Subject: OBJECTION :Planning Application 3/2024/0196 Approval of details reserved by

Conditions 9 (surface water sustainable drainage scheme) and 17 (boundary

treatment) of planning permission 3/2019/1104.

Objections to discharge of Condition 17 - 3/2019/1104

Street scene from Park Avenue looking west

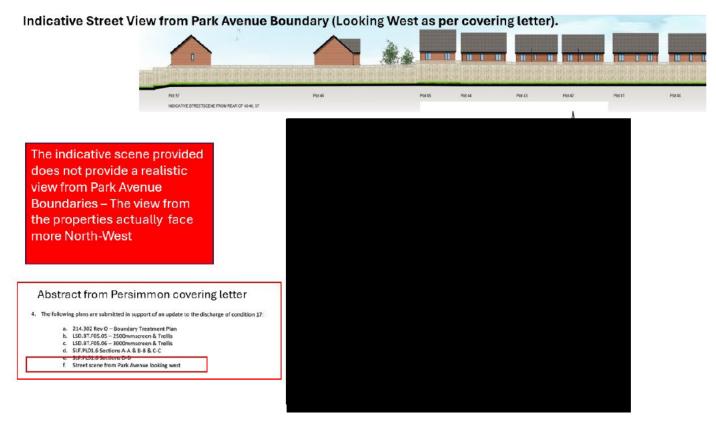
As demonstrated on Persimmons own drawings the rear of properties on <u>do not</u> face West they in fact more North-West facing.

Whilst I appreciate that is an "Indicative view" the image is deceptive and is not reflective of the true views residents will be forced to have should this application be successful. I also raised this during my recent
